Stakeholder Comment Request – Draft Market Rules and Market Manuals

MR-00439-R00-05 – Transitional Capacity Auction

<p>Date Submitted: <i>June 4, 2019</i></p> <p>Feedback Due: June 5, 2019</p>	<p>Feedback provided by:</p> <p>Company Name: Ontario Power Generation</p> <p>Contact Name: Jin Kim</p> <p>Phone: [REDACTED]</p> <p>Email: [REDACTED]</p>
--------------------------------------------------------------------------------------------	------------------------------------------------------------------------------------------------------------------------------------------------------------------

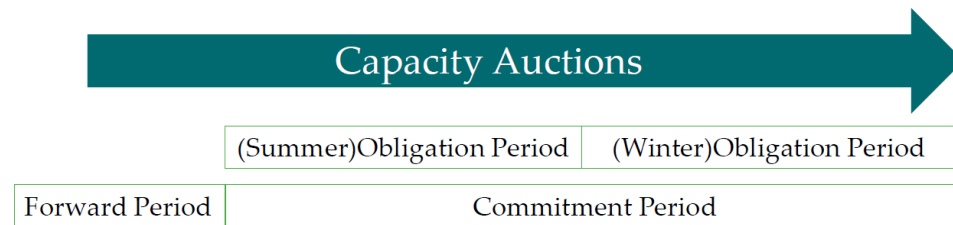
- It appears that Figure 3-3, which illustrates the commitment and forward period, has been removed. To make things clear for Market Participants, please consider using the Capacity Auction timeline figure from Page 22 of the "Transitional Capacity Auction Draft Phase 1 Design" presentation dated May 22, 2019 (see image below)
